**URGENT FIELD SAFETY NOTICE  
 MEDICAL DEVICE CORRECTION**  
**FSCAs 2249723-06/02/2023-010-C, 2249723-06/02/2023-011-C,  
 2249723-06/02/2023-013-C & 2249723-06/02/2023-014-C**  
**Datascope Cardiosave Hybrid and Rescue Intra-Aortic Balloon Pumps (IABP)**

Datascope Corp., a subsidiary of Getinge is initiating a voluntary Medical Device Correction for the Cardiosave Hybrid and Cardiosave Rescue Intra-Aortic Balloon Pump (IABP) due to the following four (4) identified system conditions:

Figure 2-5: Grasping the Fiber-Optic sensor connector

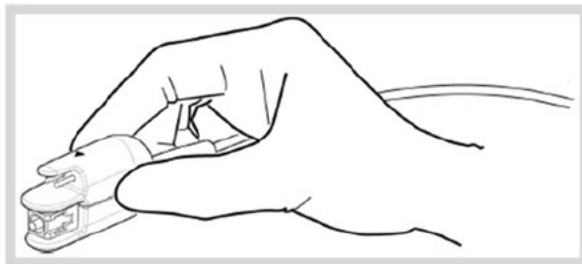
The Fiber Optic connector is designed to fit smoothly into the IAB Sensor Input. The red triangle on the top of the connector should align with the red triangle on the Cardiosave console. Inserting the Fiber Optic connector into the port without verifying the correct alignment can lead to internal damage. If difficulty is encountered when inserting the connector, verify that the connector is in the correct position and attempt to reinsert into the IAB Sensor Input.

Excessive force can cause damage to the connector and the internal fiber optic assembly of the IABP console. This may cause a disruption in the fiber optic signal acquisition resulting in an inability to acquire a fiber optic signal on the Cardiosave IABP. Following proper insertion procedures will minimize the potential for damage to the connector and a loss of signal. This conclusion is based on field observations seen through the complaints evaluation. As part of Datascope's investigation testing will be performed to confirm this observation.

1. With one hand, grasp the Fiber-Optic Sensor Connector as shown in Grasping the Fiber-Optic sensor connector, with the red triangle visible on top.

2. Remove and discard the protective cover from the Fiber-Optic IAB connector. Do not touch the exposed end of the Fiber-Optic cable.
3. With the other hand, open the protective shutter that covers the opening for the IAB Sensor Input (item 11, section 1.5.1) by rotating it to the left.
4. Insert the Fiber-Optic IAB connector into the IAB Sensor Input until it “clicks”.

Ensure that the red triangles on the Fiber-Optic IAB Sensor Connector and on the back panel are in alignment.

In step 4, when the Fiber-Optic connector is inserted into the IAB Sensor input until an audible “click” is confirmed, ensure that you are not using excessive force as that can lead to damage to the Cardiosave.
